**SITE PLAN REVIEW COMMITTEE
MEETING AGENDA & STAFF REPORT**

DATE: Monday, December 12, 2016
TIME: 7:00 – 8:30 p.m.
PLACE: 2100 Clarendon Boulevard
Courthouse Plaza
Room 109/110 (Cherry & Dogwood)
Arlington, VA 22201

Item 1. 1555 Wilson Boulevard (SP #445) 7:00pm–8:25pm
(RPC# 16-033-008, -009, -010, -011, -012, -013, -014, -016, -017, -018, -021, and
-022)
Planning Commission and County Board meetings scheduled for February 2017.
Samia Byrd (CPHD Staff)

Shadow Study - September

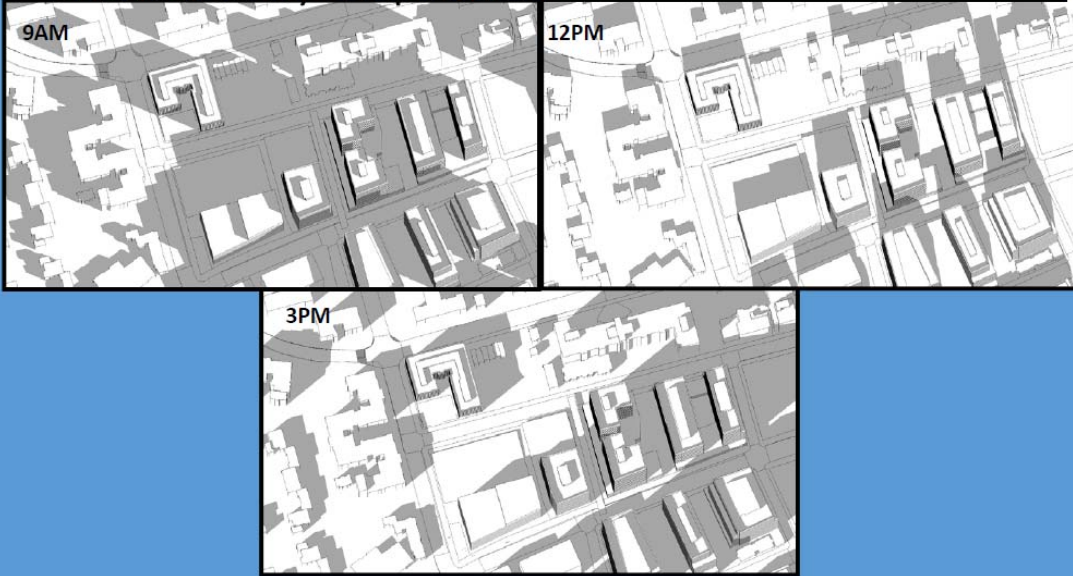
- Impact of the height and mass of the proposed buildings on the new street and the park with respect to air and light. Shadow studies were requested to be provided by the SPRC.

Attached to this SPRC report are shadow studies provided during the WRAPS and updated studies specific to the proposed site plan buildings prepared by the Applicant.
